GULLEN RANGE WIND FARM- MODIFICATION Turbine Locations

(MP 07_0118 MOD 1)

Figure 2: Location of the Gullen Range Wind Farm Project - Northern Turbines

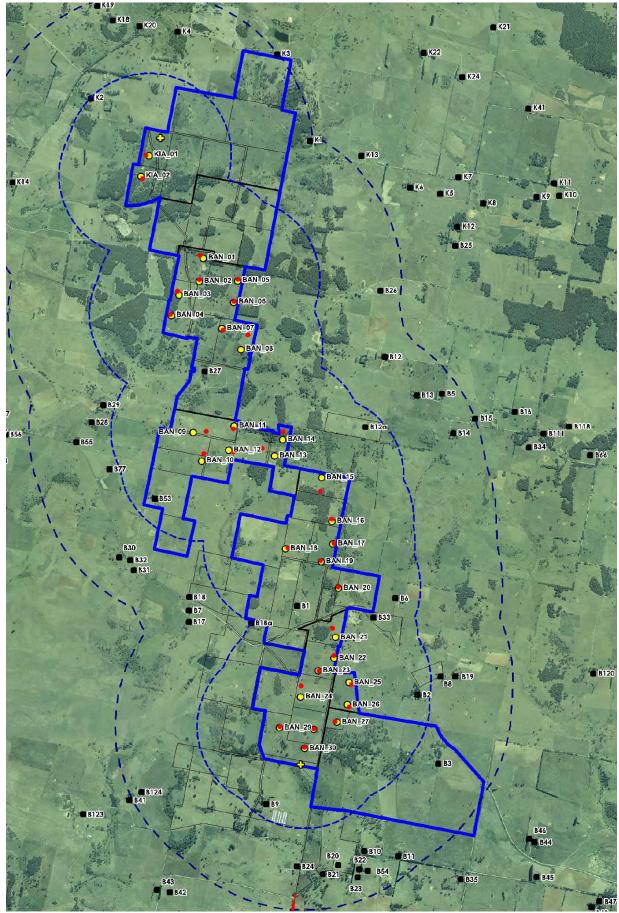
Five of these turbines are located in the northern part of the site (i.e. BAN_08, BAN_09 and BAN_12, BAN_13 and BAN_15), and were moved closer to non-associated residents (i.e. B12 and B29) and were considered to result in unacceptable visual impacts (see Figure 2).

B12 has 5 turbines between 1.6 km and 2 km from the residence of which two turbines have moved closer - BAN_13 by 65 metres and BAN_15 by 166 metres. Of the 9 turbines within 2 km of B29, 6 turbines have moved closer to the residence, of which 3 turbines have moved closer by more than 50 metres (i.e. BAN_08 146 metres; BAN_09, 162 metres; and BAN_12, 64 metres).

To reduce visual impacts on these residences, the Department recommended in its July 2014 report that the 2 turbines that had moved more than 150 metres towards the residences be moved back to their approved locations (i.e. turbines BAN_09 and BAN_15). The Department also recommended that B29 be afforded voluntary acquisition rights under the project approval.

- acquired property B29; and
- reached a negotiated agreement with the owner of property B12 to accept the impacts of the wind farm "as constructed".

Consequently, both properties can be considered to be "associated" with the project, and the measures previously recommended by the Department are no longer necessary.

Figure 3: Location of the Gullen Range Wind Farm Project - Southern Turbines

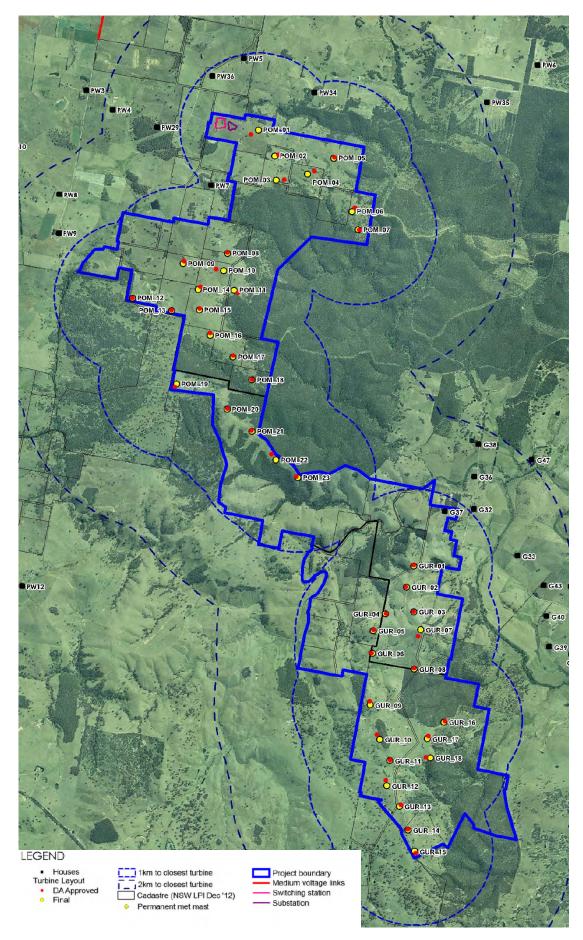
The remaining 4 turbines (i.e. POM_03, POM_04, POM_06, POM_07) are located in the southern part of the site, and their movement was considered to increase the risk to known habitat for the Powerful Owl and Little Eagle which has increased the risk to biodiversity (see Figure 3).

Figure 4: Location of the Northern Pomeroy Turbines

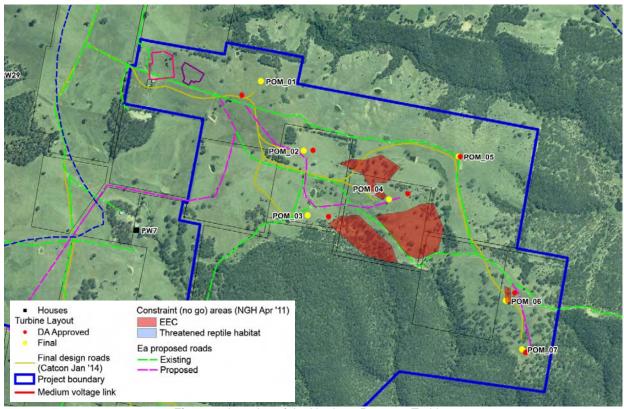
The Draft Order considered that POM_03, POM_04, POM_06, POM_07 had moved to the extent that the turbines created increased risk to biodiversity, particularly in regard to the Powerful Owl and the Little Eagle. The location of these turbines with respect to ecological constraints is presented in Figure 4.

All of these reports provide consistent conclusions – that the risk of collisions for key species of concern (i.e. Powerful Owl and Little Eagle) with the 4 relocated turbines has not materially increased. This includes the Department's independent expert (Dr Kevin Mills) who concluded that:

- in respect of turbines POM_03, POM_04 and POM_07, the environmental and biodiversity outcome is better with the turbines relocated than it was as approved; and
- in relation to turbine POM_06, the impact is the same in environmental and biodiversity terms.

The Department notes that OEH considered that the turbines POM_03, POM_04, POM_06 and POM_07 had moved closer to the known habitat for the Little Eagle. To address the increased risks, OEH recommended consideration of temporary suspension of operation of POM_03 and POM_04 during the fledging period for the Little Eagle.

Given this, and the fact that the advice from a number of experts is that the relocated turbines would have no material effect on the risks to both species, the Department considers that there is little justification, at this stage, for imposing an additional suspension of turbine operations in this area to protect the Little Eagle.

Nonetheless, the Department has recommended that the Little Eagle be added to the list of "at risk" species in the Bird and Bat Adaptive Management Plan condition (see condition 3.1(d)). This requires monthly mortality assessments and periodic local population censuses and bird utilisation surveys to be undertaken for these species.
